Re: Contract N62470-02-D-3052
Navy CLEAN, District III
Contract Task Orders (CTO) 0121
U.S. Naval Activity Puerto Rico (NAPR)
Navy Responses to EPA Comments dated June 11, 2007
EPA I.D. No. PR2170027203

NAVY RESPONSES TO EPA COMMENTS DATED JULY 27, 2007

**EPA COMMENTS ON THE NAVAL ACTIVITY PUERTO RICO
DRAFT RCRA FACILITY INVESTIGATION REPORT
FOR SWMU 16-FORMER WASTE EXPLOSIVES STORAGE BUILDING
DATED MARCH 26, 2007**

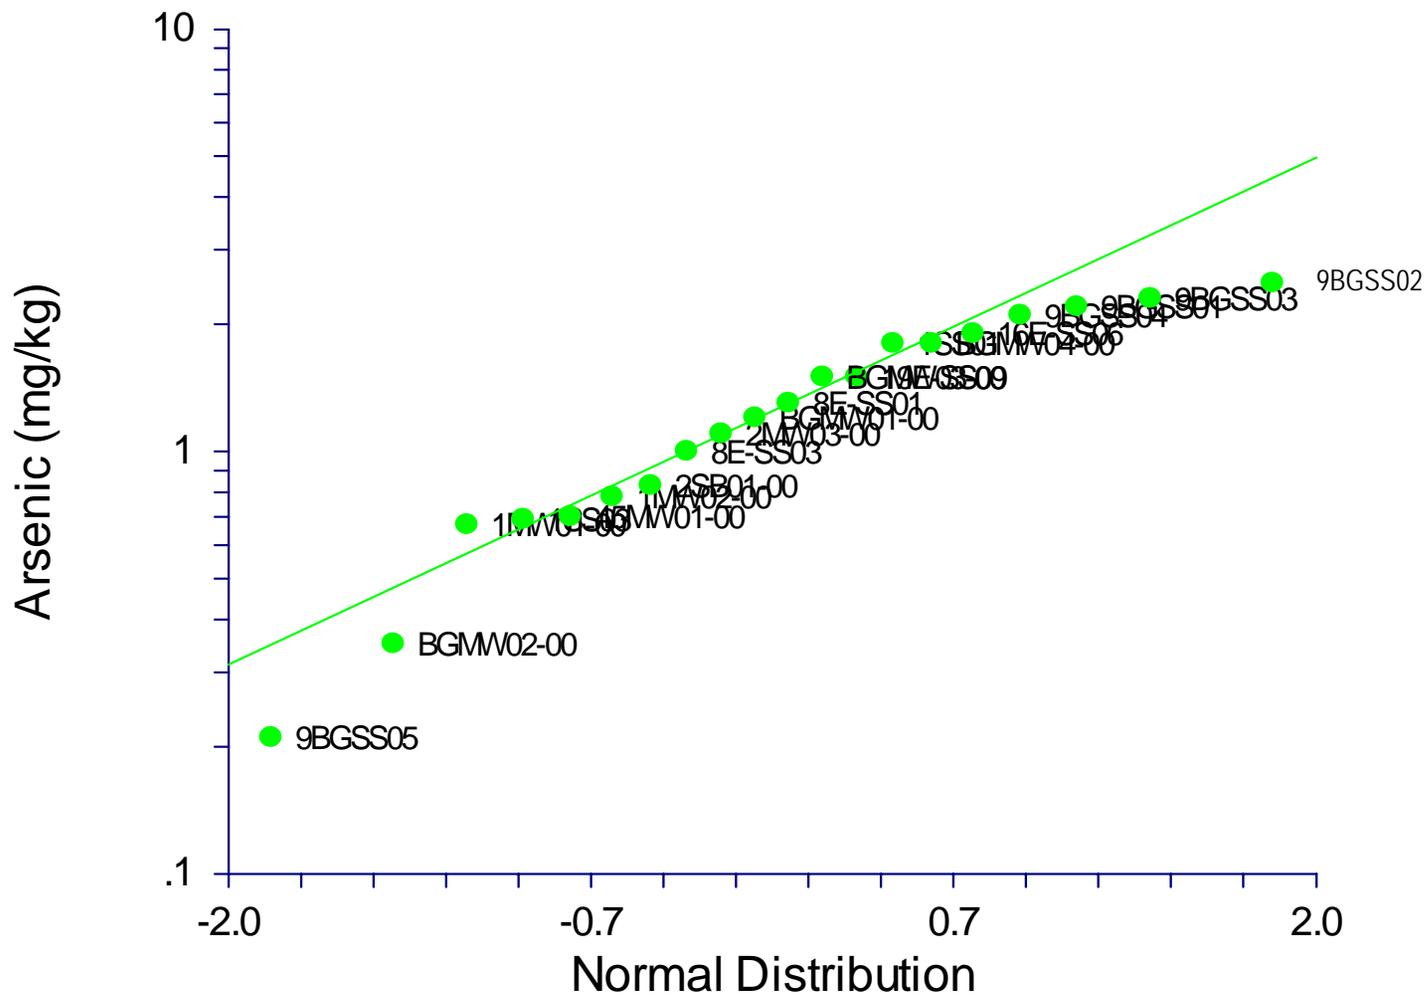
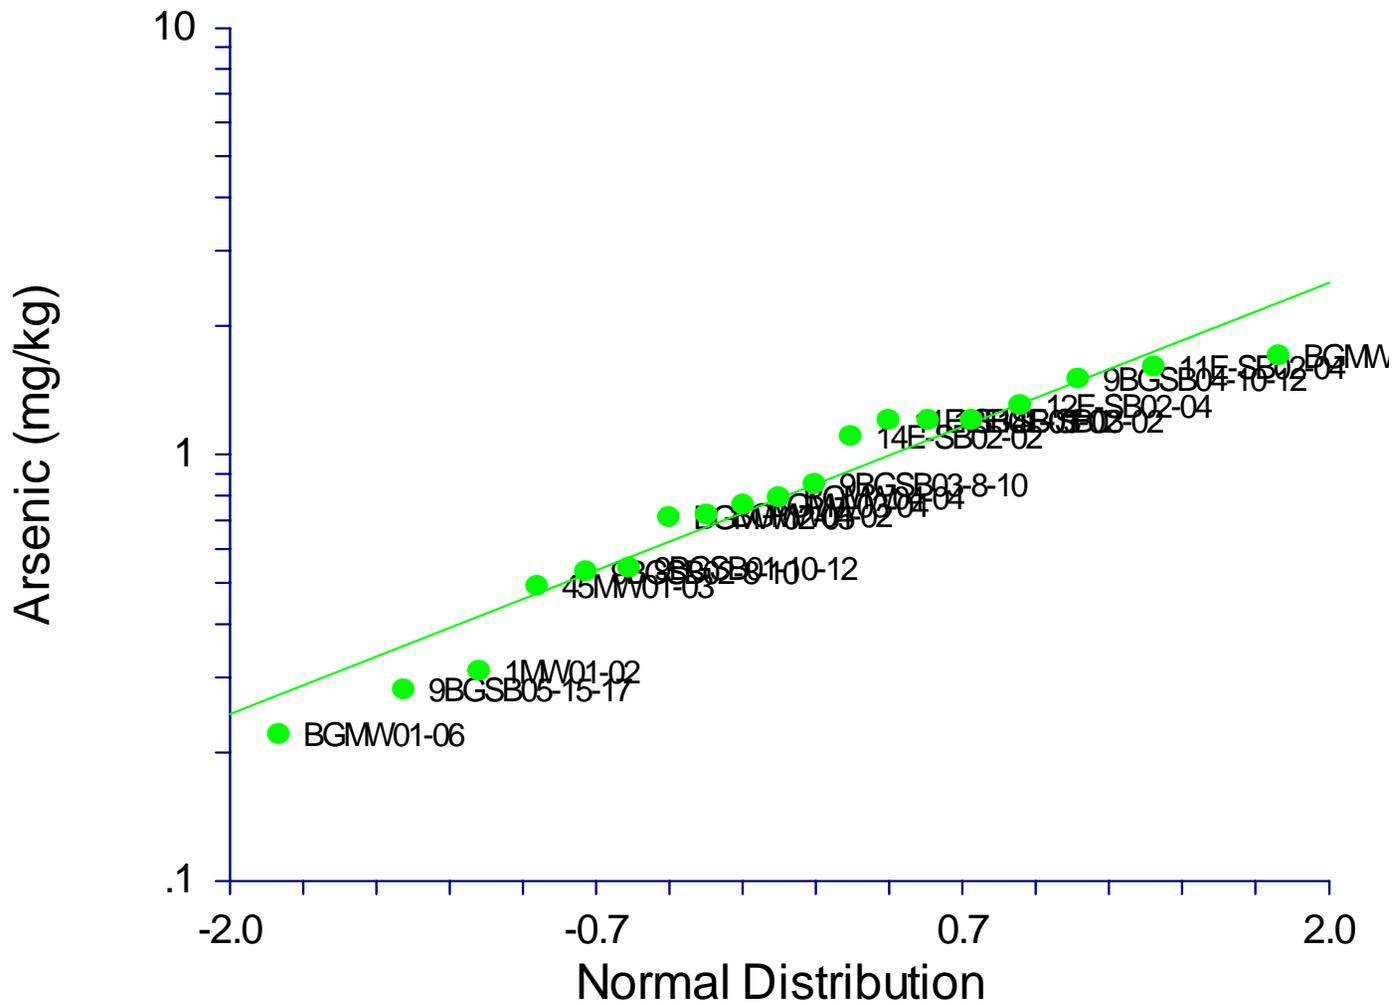
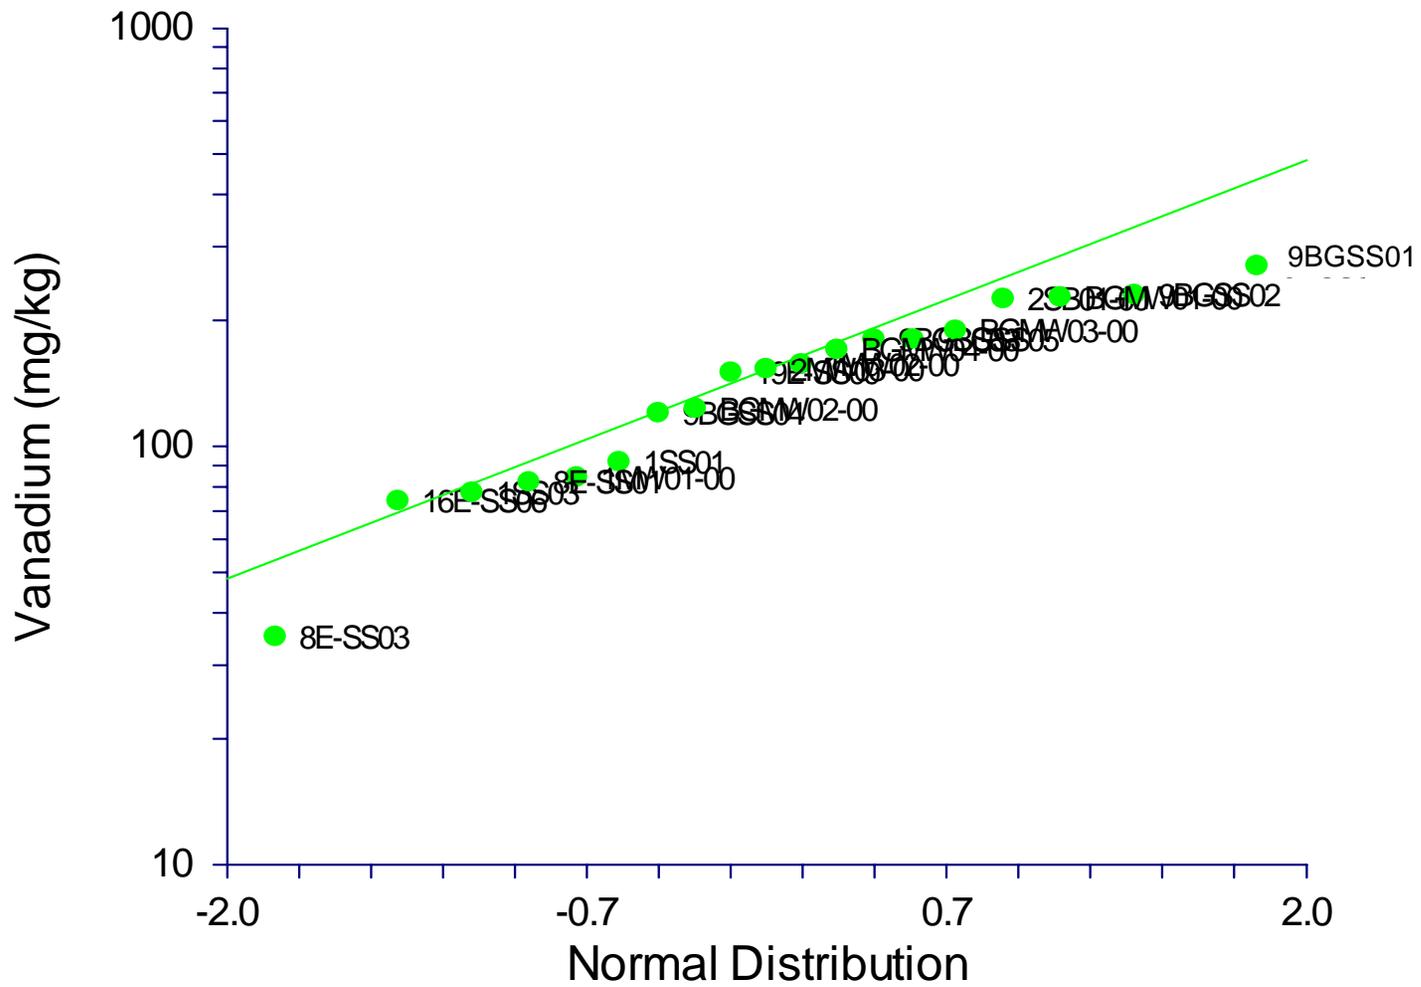
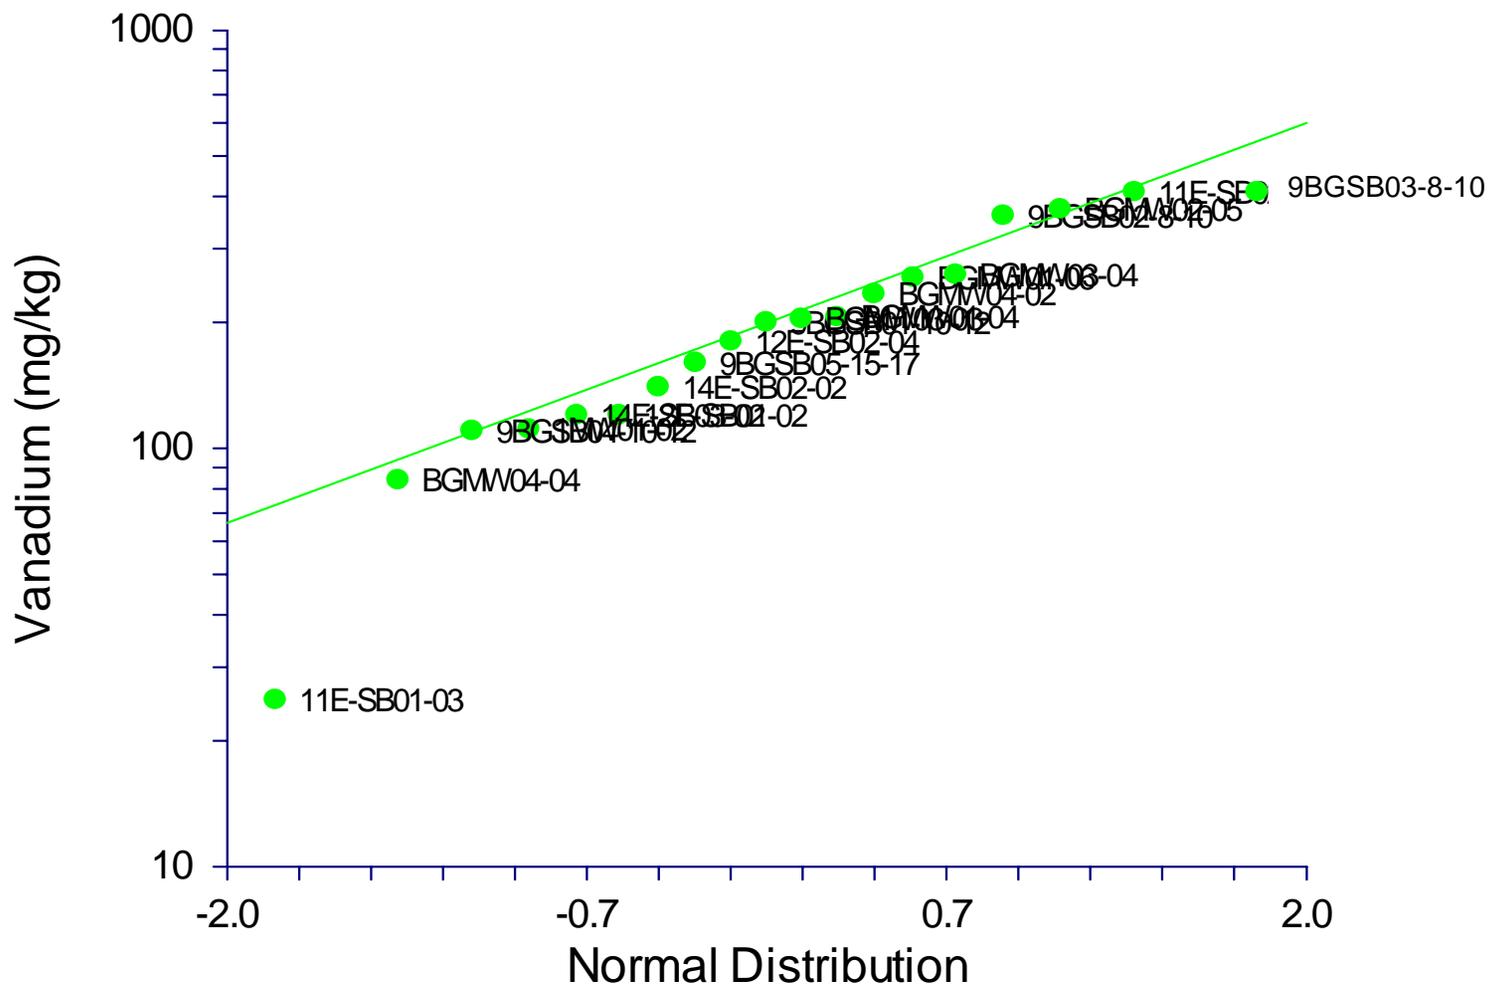
In all four surface soil and all 6 subsurface soil samples, arsenic was measured at concentrations above the residential PRG concentration, but below the industrial PRG, and below the ULMs of 2.65 mg/kg and 1.59 mg/kg for surface and subsurface soils, respectively, established under the October 2006 Background Report. Vanadium was detected in all 4 surface soils and all 6 subsurface soil samples at concentrations above both the residential and industrial PRG concentrations, but below the ULM of 287 mg/kg and 434 mg/kg, respectively as established under the base wide background concentration established in the October 2006 Background Report. However, as indicated in my letter of May 29, 2007, EPA has concerns about the ULMs established for vanadium under the October 2006 Background Report may not be truly reflective of natural site-wide conditions at the NAPR facility.

Navy Response to EPA General Comment (regarding arsenic and vanadium in soil): The EPA has previously expressed concern regarding the basewide surface soil and subsurface soil background criteria established for arsenic and vanadium within the Revised Final Summary Report for Environmental Background Concentrations of Inorganic Compounds (Baker, 2006) in a comment letter addressing the Draft RFI Report for SWMU 68 and the Final RI Report for SWMU 14 dated May 29, 2007. The Navy responded to these concerns in a letter dated July 20, 2007, which included probability plots of the basewide background surface and subsurface arsenic and vanadium soil data sets (see Figures 1 through 4 of this response to comments). As discussed in the Navy's July 20, 2007 letter, a probability plot is a graph of concentration values plotted against their cumulative probabilities. Probability plots can be used to estimate background concentration ranges by identifying outliers and differentiating between separate populations within the data sets (i.e., a population that represents background conditions and a population that represents contamination). A continuous straight-line plot with no large gaps indicates that the data represent a naturally occurring population. An inflection point or discontinuity in a probability plot may indicate the threshold separating two populations in the data set. If concentrations in the upper range depart from the line or trend shown on the probability plot (i.e., a distinct increase in slope), the upper range of the concentration distribution is likely to represent a separate population (i.e., contamination). As evidenced by Figures 1 through 4, the upper range of arsenic and vanadium concentration values within the surface soil and subsurface soil data sets do not deviate in an upward direction from the trends shown on the probability plots, supporting the conclusion that the NAPR background surface and subsurface soil data sets for these two metals are representative of background conditions.

In summary, based on the surface and subsurface soil probability plots included as Figures 1 through 4 and the comparison of the NAPR background surface soil data set to the USGS surface soil data set presented in Table 1, the Navy does not believe that background arsenic and vanadium surface and subsurface soil levels established within the revised final background report require revisions.

FIGURE 5
PROBABILITY PLOT OF VANADIUM IN NAPR
BACKGROUND GROUNDWATER
NAVAL ACTIVITY PUERTO RICO, CEIBA, PUERTO RICO

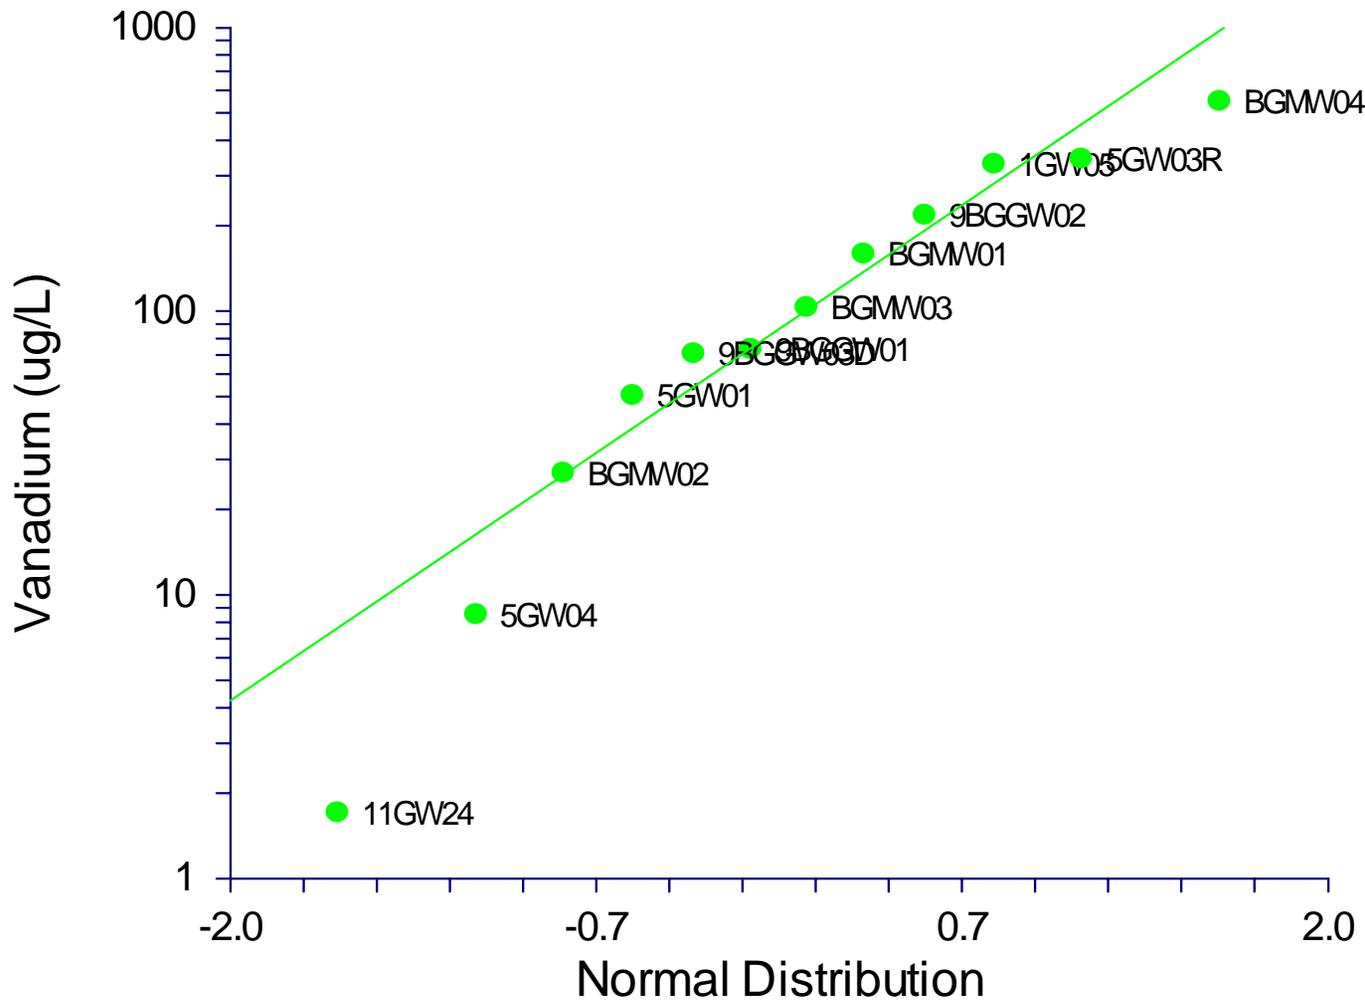
EPA also notes that the vanadium concentrations measured in the three of the four groundwater samples collected at SWMU 42, are only a fraction (between 1/100 to 1/8) of the "Upper Limit of Means" of 484.66 up/L for that constituent, as established under the base wide background concentration established in the October 2006 Background Report. This suggests to EPA that the natural occurring vanadium background levels in groundwater may not be correctly established by the October 2006 Background Report, and that as requested in my letter dated May 29, 2007, the vanadium background levels established by the October 2006 Background Report may need to be revised.

Navy Response to EPA General Comment (regarding background levels of vanadium in groundwater): The EPA has previously expressed concern regarding the basewide groundwater background criteria established for vanadium within the Revised Final Summary Report for Environmental Background Concentrations of Inorganic Compounds (Baker, 2006) in a comment letter addressing the Draft RFI Report for SWMU 68 and the Final RI Report for SWMU 14 dated May 29, 2007. The Navy responded to these concerns in a letter dated July 20, 2007, which included a probability plot of the basewide background groundwater data set (see Figure 5 attached to this response to comments). As evidenced by Figure 5, the upper range of concentration values within the background groundwater data set does not deviate in an upward direction from the trend shown on the probability plot, supporting the conclusion that the NAPR background groundwater data set is representative of background conditions. Therefore, the Navy does not believe that background vanadium groundwater levels established within the revised final background report require revisions.
